# **BELMONT LAKE ESTATES SUBDIVISION, PHASE**

## **II**

The purpose of this application is to create a five-lot subdivision from a metes and bounds parcel.

APPLICATION NUMBER 9 DATE November 20, 2003  
APPLICANT Belmont Lake Estates Subdivision, Phase II  
REQUEST Subdivision

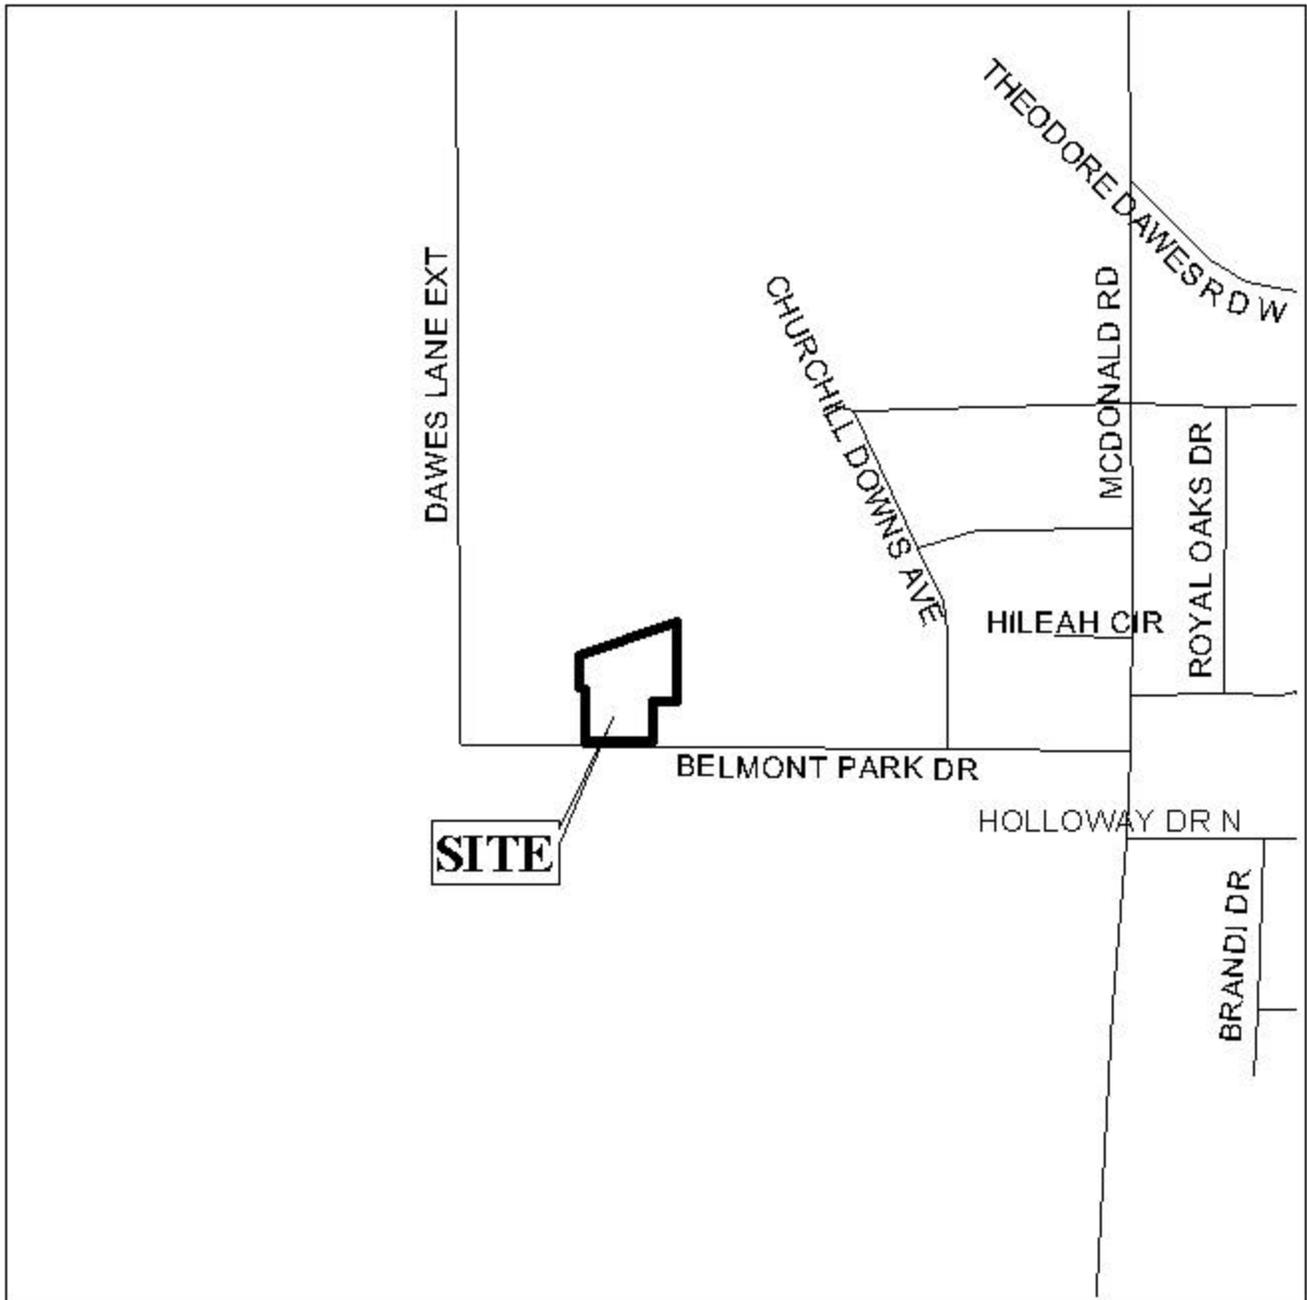
Lots 1 and 5 of the proposed subdivision front both Belmont Park Drive and the new street; therefore, both lots should be denied direct access to Belmont Park Drive.

The detention area is labeled as common area, thus a note on the final plat stating that the maintenance of the common area is the responsibility of the property owners, should be required.

As illustrated on the plat, the drainage easement along Lot 1 and portions of Lot 2 is only five feet wide; the Subdivision Regulations require a minimum width of 7½ feet.

With modifications, the plat meets the minimum requirements of the Subdivision Regulations and is recommended for Tentative Approval subject to the following conditions: 1) the placement of a note on the final plat stating that Lots 1 and 5 are denied direct access to Belmont Park Drive; 2) the placement of a note on the final plat stating that maintenance of all common areas are the responsibility of the property owners; 3) that the drainage easement along Lot 1 and portions of Lot 2 to be increased to 7½ feet; 4) the placement of a note on the final plat stating that any lots which are developed commercially and adjoin residentially developed property must provide a buffer, in compliance with Section V.A.7. of the Subdivision Regulations; and 5) the developer obtain any necessary approvals from all applicable federal, state and local agencies prior to the issuance of any permits.
